WORCESTER COUNTY PLANNING COMMISSION AGENDA

Thursday, November 5, 2026

III. Waiver Request – 611 Holdings II Storage Yard

IV. Major Site Plan Review – Bayside Jet Drive

COVER SHEET
MINOR SITE PLAN

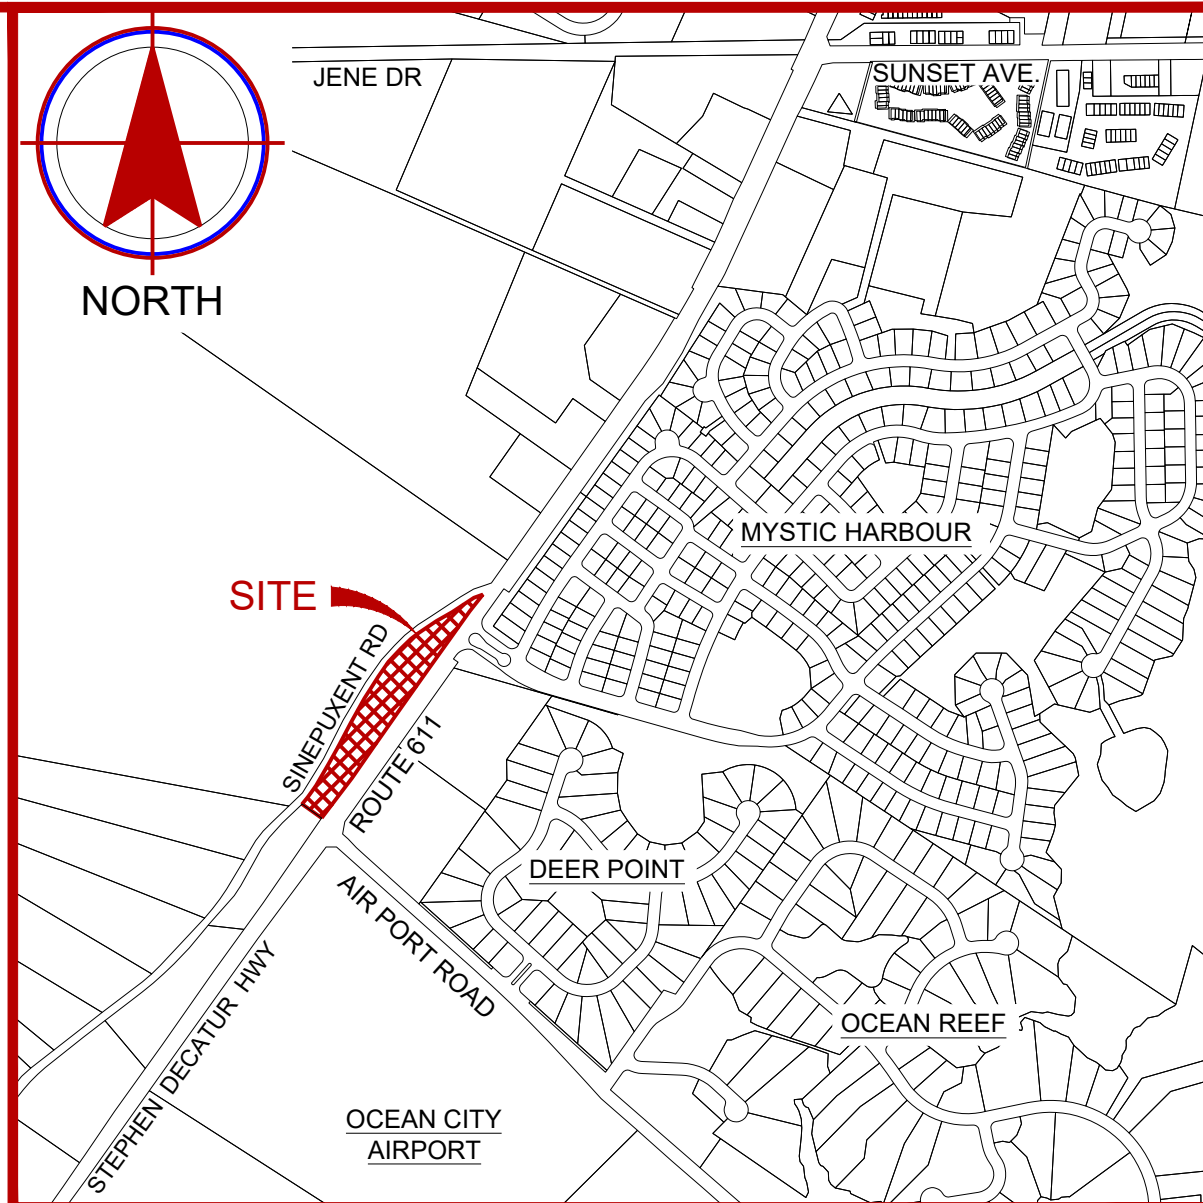
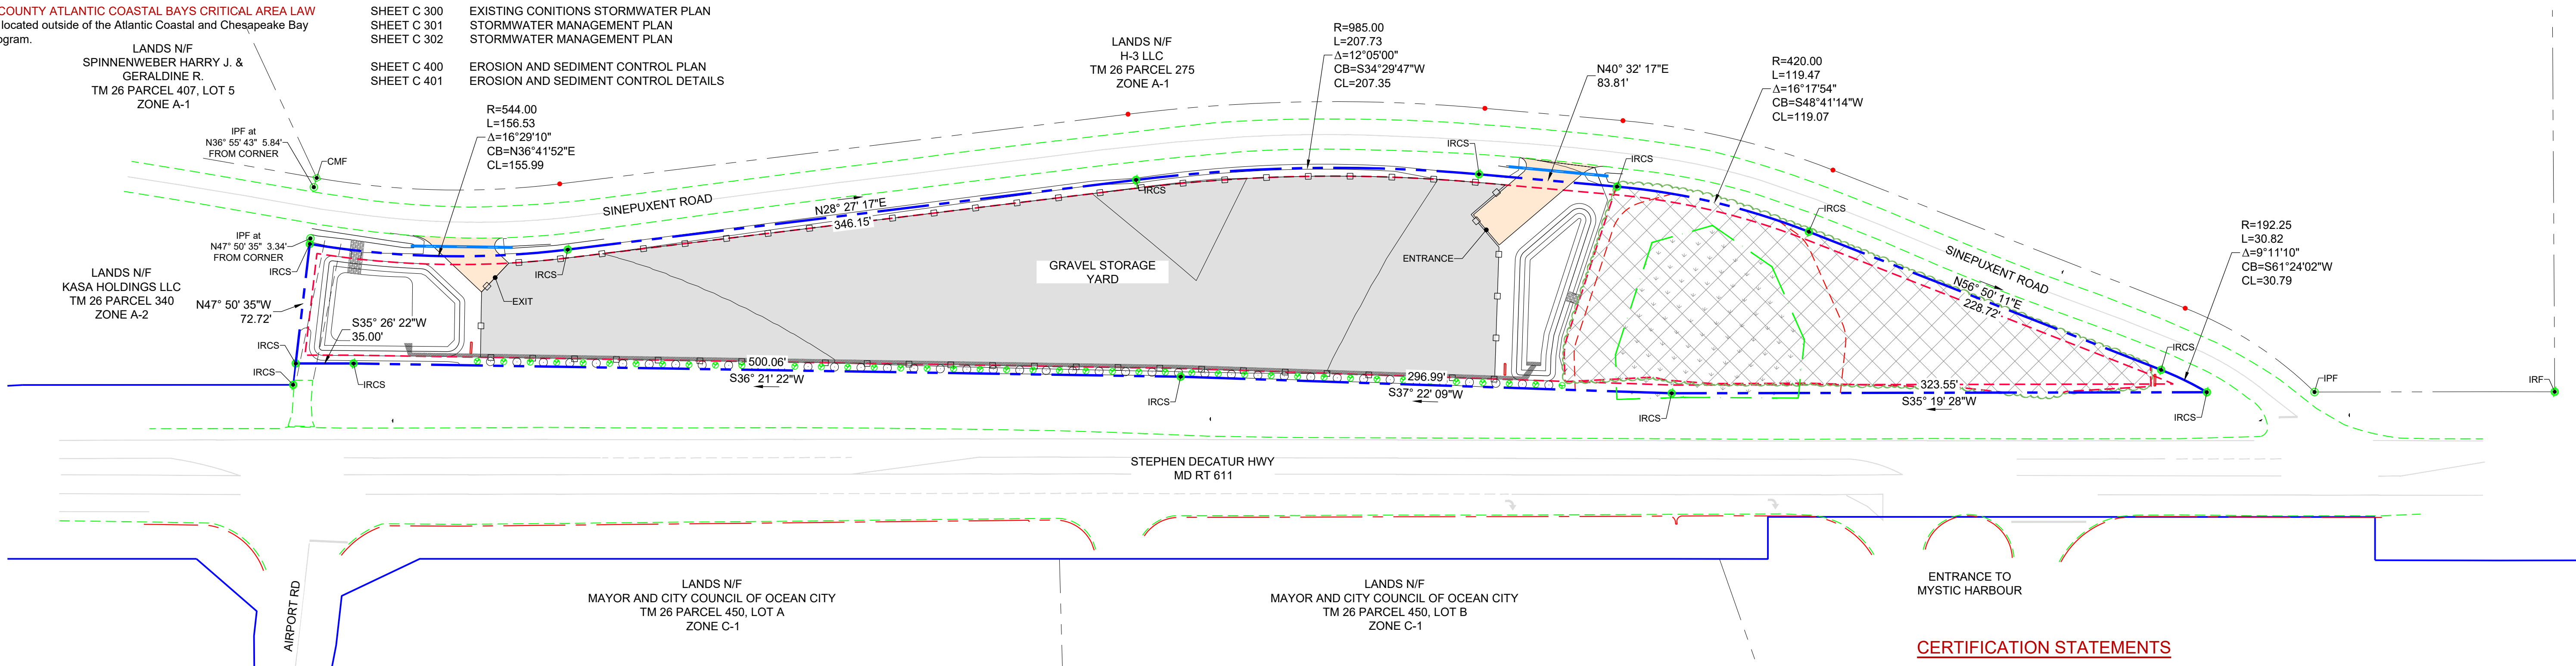
Pursuant to §ZS1-322(e), the Applicant respectfully requests that the Planning Commission waive the landscape screening standards applicable under §ZS1-209(c)(14) to permit an 8-foot-high chain-link fence with black privacy slats along the north, south, and west sides and an 8-foot-high black board-on-board fence with a 5-foot landscaped strip along Maryland Route 611 to provide additional screening and break up the continuous appearance of the fence.

- Gravel Storage Yard Surface ZS 1-320 (f)(1)-Previously Granted October 1, 2026**
 - Request a waiver to permit gravel surface for the storage yard.
- Screening ZS 1-322 (e)(4)**
 - Request the Planning Commission to waive the requirement concerning visual screening, via landscaping, between incompatible land uses.

Project No.:	23-05I
File Name:	SP 07I526.dwg
Sheet No.:	C 200

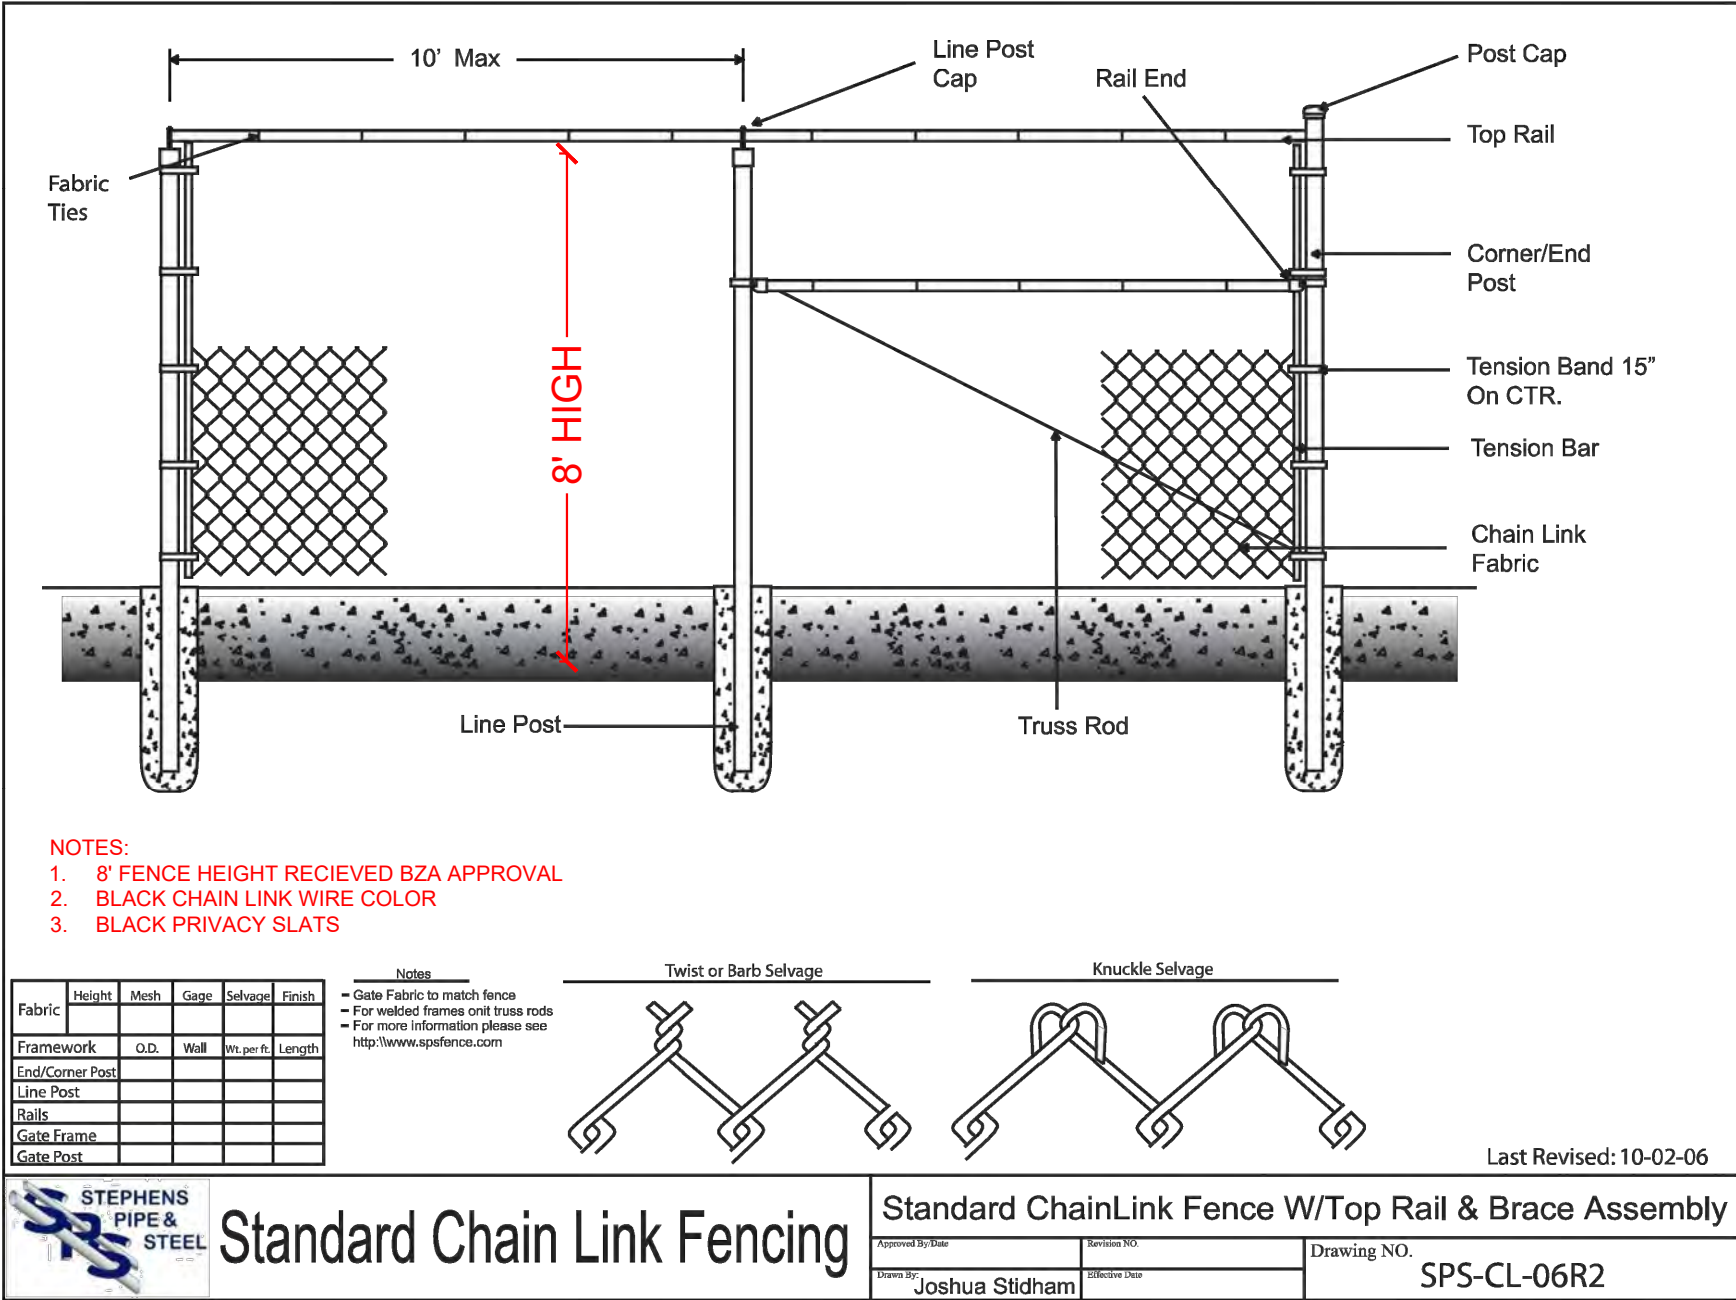
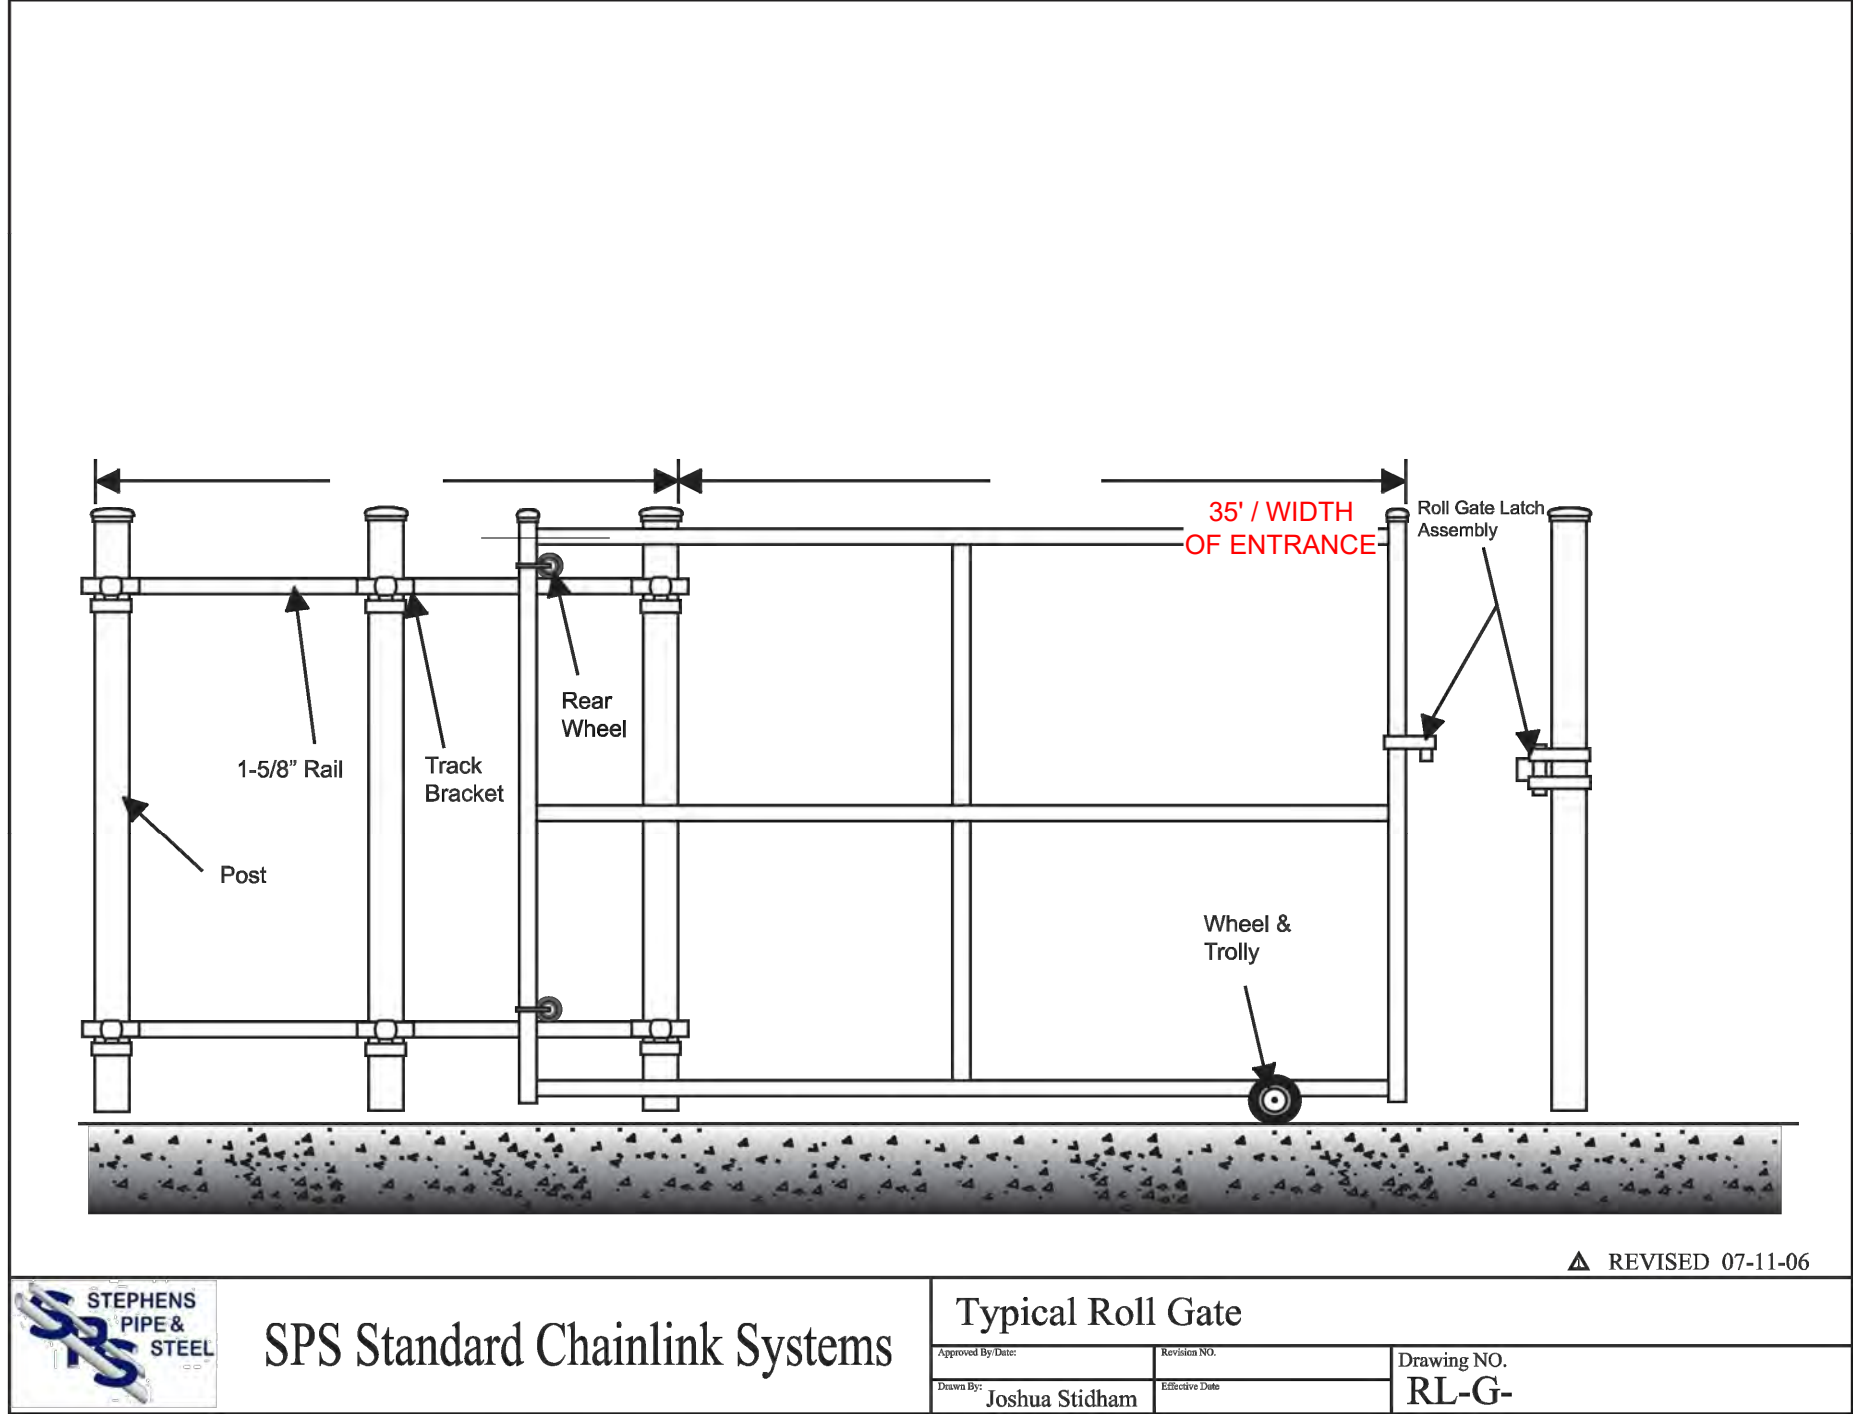
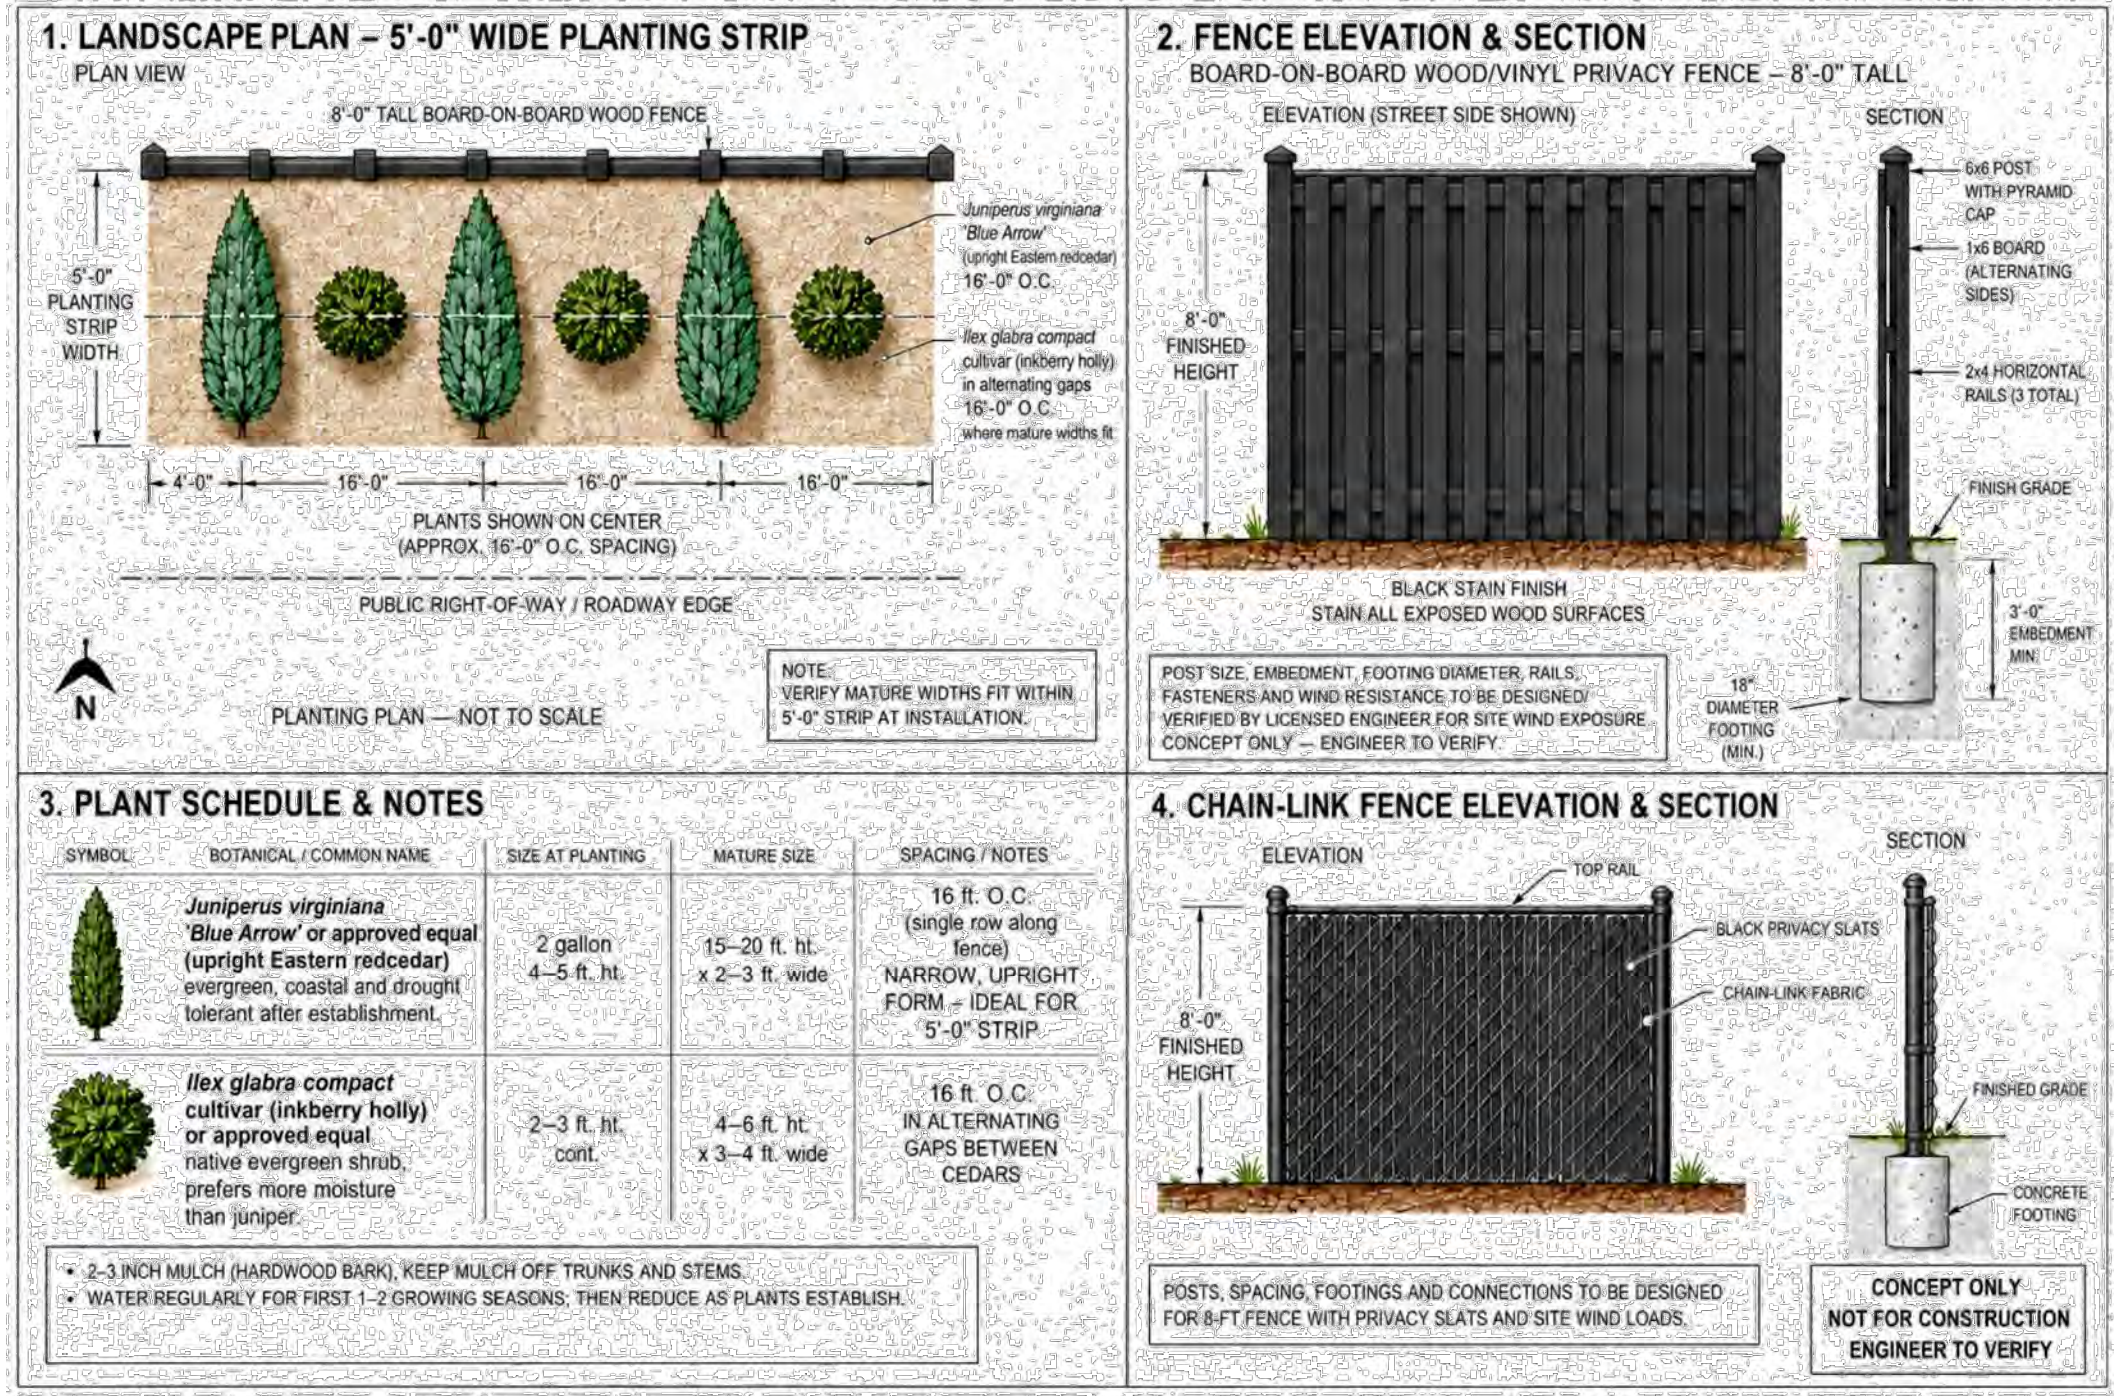
The site plan proposes an 8-foot-high chain-link fence with black privacy slats along the north, south, and west sides of the storage yard. Along the primary eastern road frontage on Maryland Route 611, the plan proposes an 8-foot-high black stained board-on-board fence with a 5-foot landscape strip.

The 5-foot landscape strip along Maryland Route 611 will be planted with alternating Blue Arrow red cedar and inkberry holly. This planting arrangement will add layered screening and break up the continuous appearance of the board-on-board fence.

Along Sinepuxent Road, a drainage swale is located between the proposed slatted chain-link fence and the road. Planting screening material within the swale would interfere with drainage conveyance and routine maintenance and could reduce its functional capacity.

1. **Screening ZS 1-322 (e)(4)**
 - Request the Planning Commission to waive the requirement concerning visual screening, via landscaping, between incompatible land uses
